Errata to
Advanced Energy Design Guide for Grocery Stores—
Achieving 50% Energy Savings Toward a Net Zero Energy Building
(2015)

April 29, 2015

Figure 5-13 (DL8) Daylighting Ceiling Configurations:
(a) Raised Ceiling at Façade and (b) Sloped Ceiling at Façade

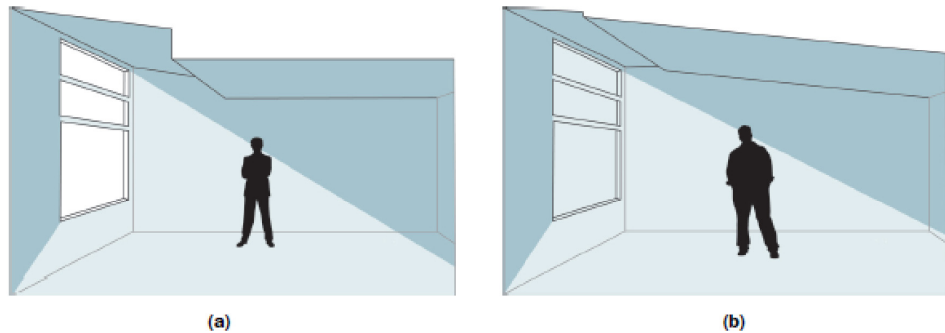
The figure caption needs to include “**(DL8)**” at the beginning of it, and the (a) and (b) for the figures need adjusting. Please refer to the following corrected figure:
